**Invention:** OXYGEN-FUEL BURNER WITH  
INTEGRAL STAGED OXYGEN  
SUPPLY

**Serial No:** 08/954,291

Application to Reissue  
U.S. Patent No. 5,458,483  
Issued October 17, 1995  
on U.S. Application Serial No. 163,424  
Filed December 8, 1993

**PROPOSED AMENDMENTS TO THE DRAWINGS**  
**UNDER 37 C.F.R. § 1.121(b) (3)**

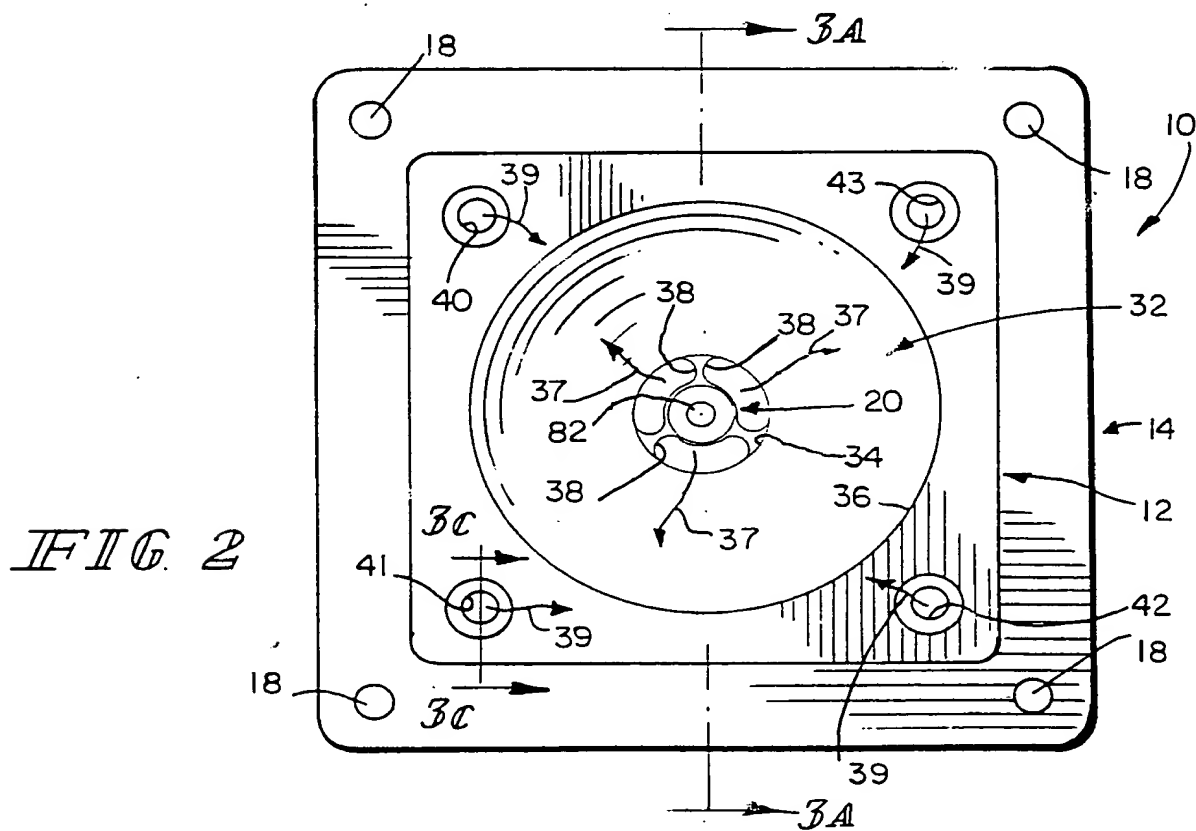
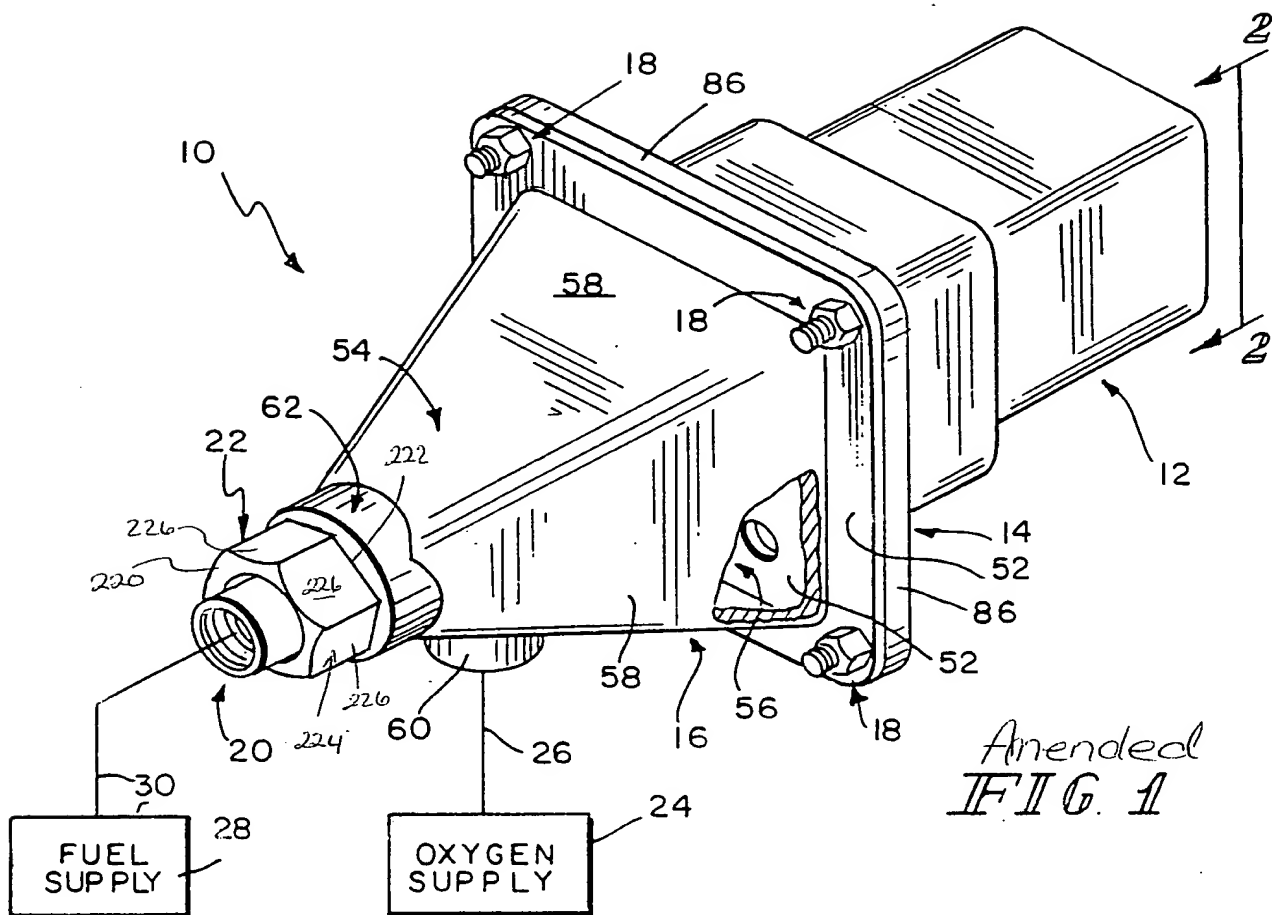
Please amend Fig. 1 of the drawings to include a reference numeral 220 referring to an outer surface of removable collar 22; reference numeral 222 referring to an inner surface of removable collar 22; reference numeral 224 referring to an external side wall of removable collar 22; and reference numerals 226 referring to bounding surfaces of side wall 224.

FIG. 3A

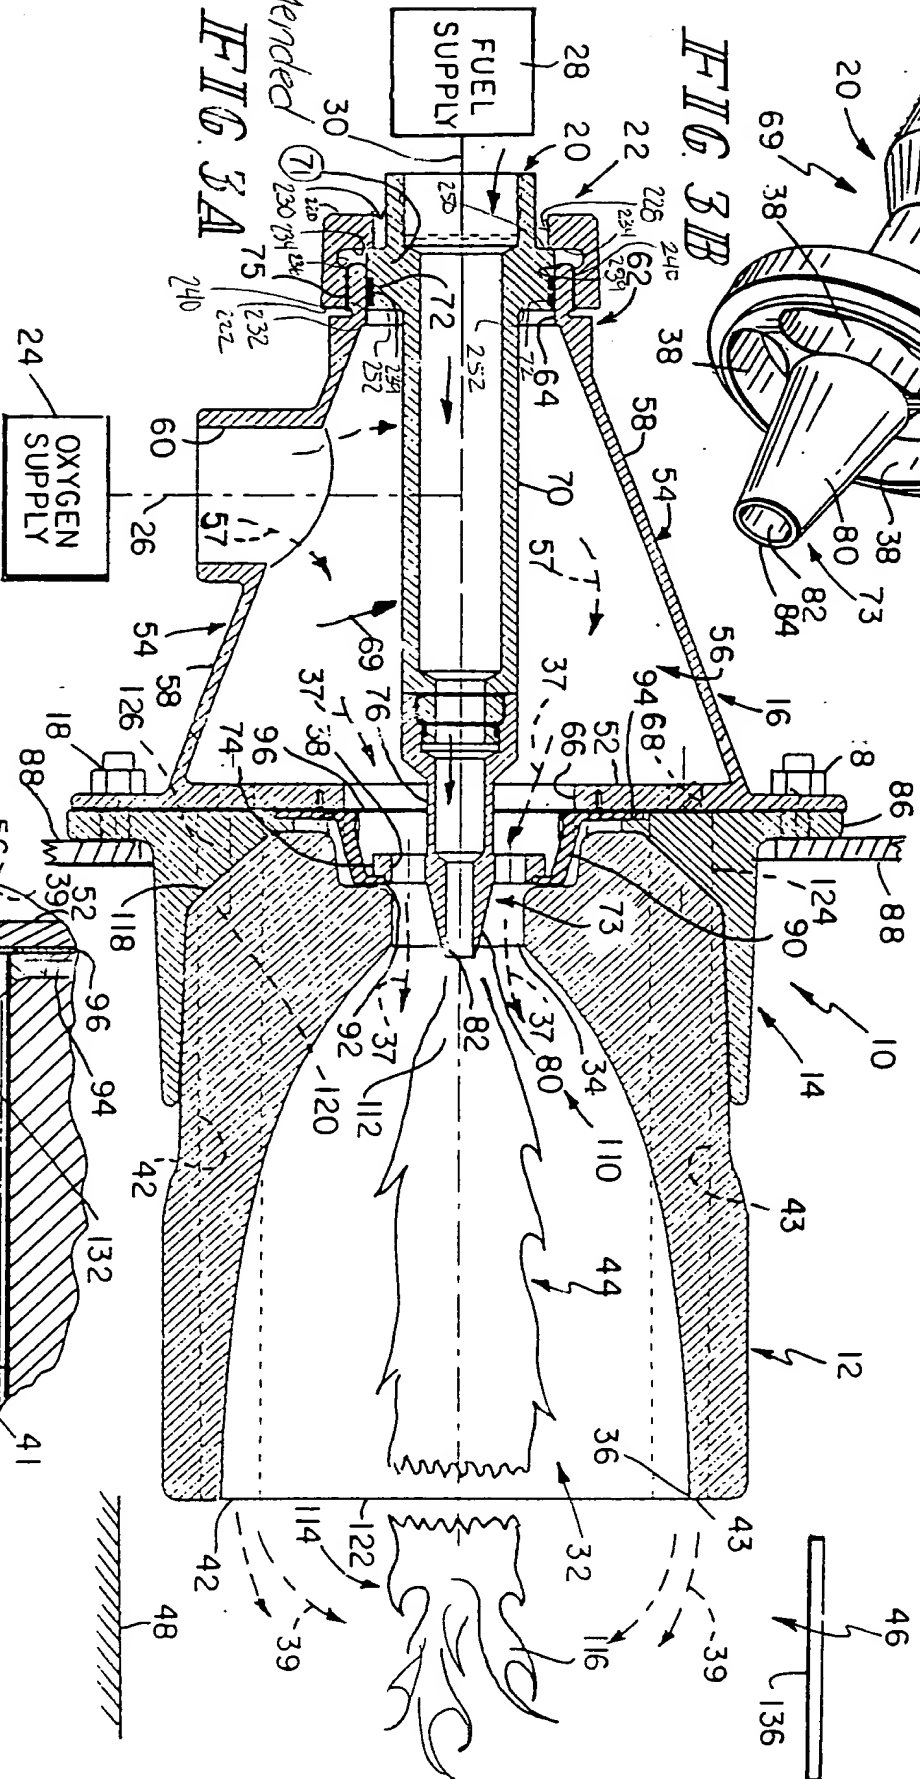
Please amend Fig. 3A of the drawings to change reference numeral 7 referring to a mounting fixture of gas conduit 70 to reference numeral 71. In addition, please amend Fig. 3A of the drawings to include reference numeral 72 referring to O-ring seals; reference numeral 220 referring to an outer surface of removable collar 22; reference numeral 222 referring to an inner surface of removable collar 22; reference numeral 228 referring to an internal side wall of removable collar 22; reference numeral 230 referring to a passageway between outer and inner surfaces 220, 222; reference numeral 232 referring to a threaded portion of internal side wall 228; reference numerals 234 referring to limit tab of internal side wall 228; reference numeral 236 referring to a recess in internal side wall 228; reference numerals 239 referring to an inner surface of rear lip portion 75; reference numerals 240 referring to an outer surface of rear lip portion 75; reference numeral 250 referring to an outer end of mounting fixture 71; and reference numerals 252 referring to an inner end of mounting fixture 71.

Amended FIG. 7

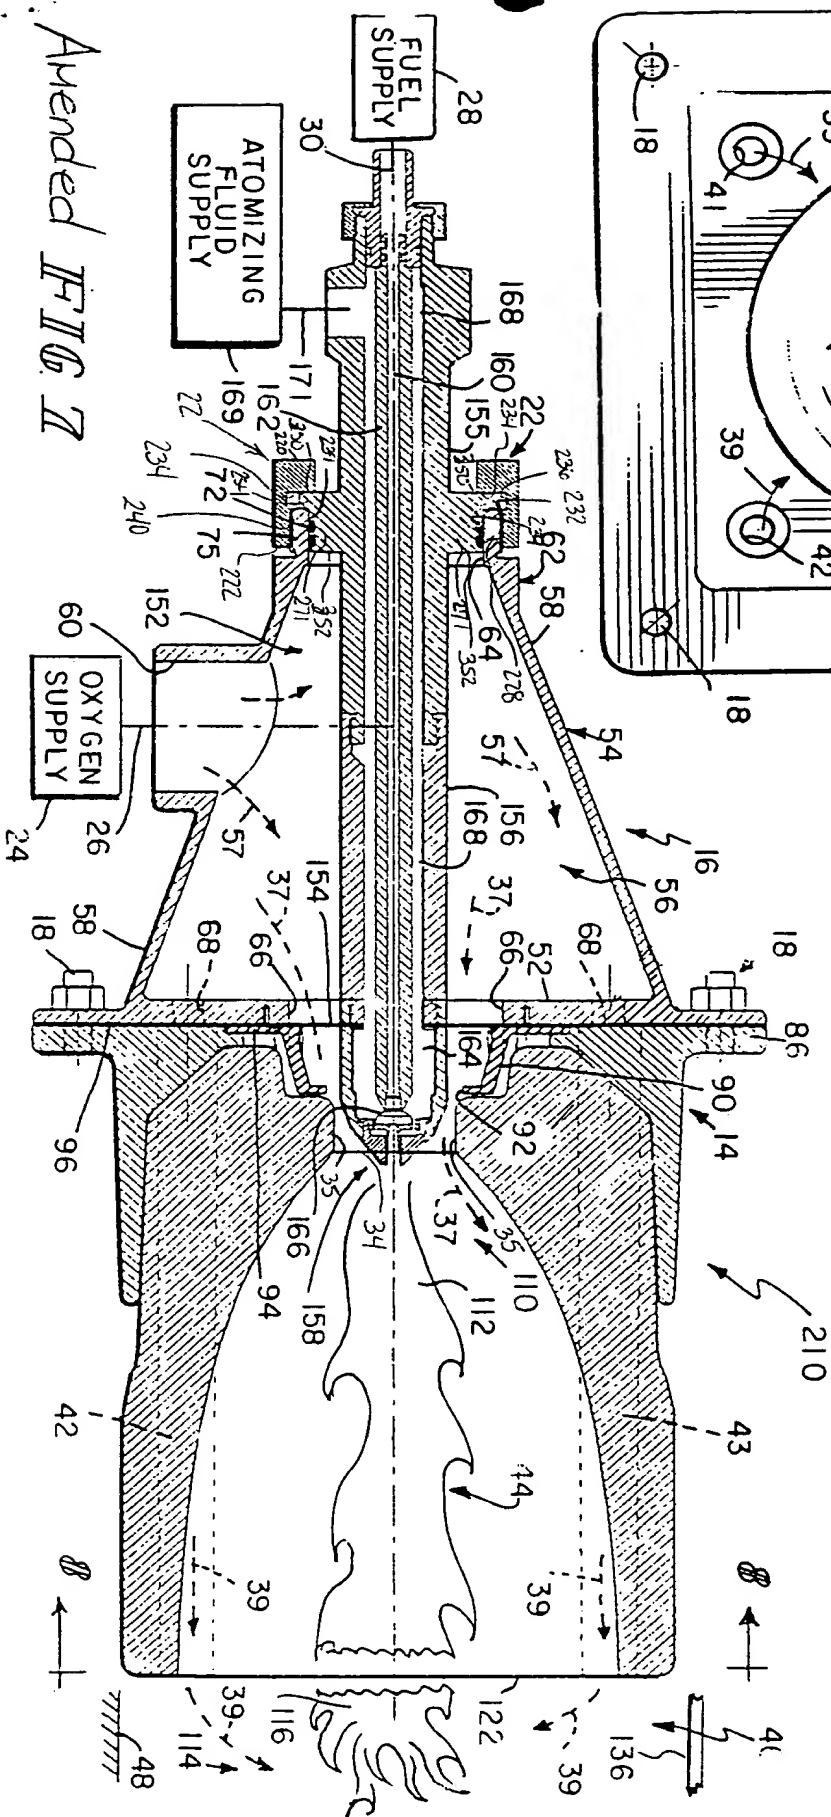
Please amend Fig. 7 of the drawings to include reference numeral 22 referring to the removable collar; reference numeral 34 referring to an inlet opening of flame chamber 32; reference numerals 35 referring to a wall defining inlet opening 34; reference numeral 220 referring to an outer surface of removable collar 22; reference numeral 222 referring to an inner surface of removable collar 22; reference numerals 271 referring to a mounting fixture on body portion 155 of fuel-delivery assembly 152; reference numeral 228 referring to an internal side wall of removable collar 22; reference numeral 232 referring to a threaded portion of internal side wall 228; reference numerals 234 referring to a limit tab of internal side wall 228; reference numeral

236 referring to a recess in internal side wall 228; reference numerals 239 referring to an inner surface of rear lip portion 75; reference numeral 240 referring to an outer surface of rear lip portion 75; reference numerals 350 referring to an outer end of mounting fixture 271; reference numerals 352 referring to an inner end of mounting fixture 271; and reference numeral 254 referring to a lip portion of mounting fixture 271 adjacent outer end 350.
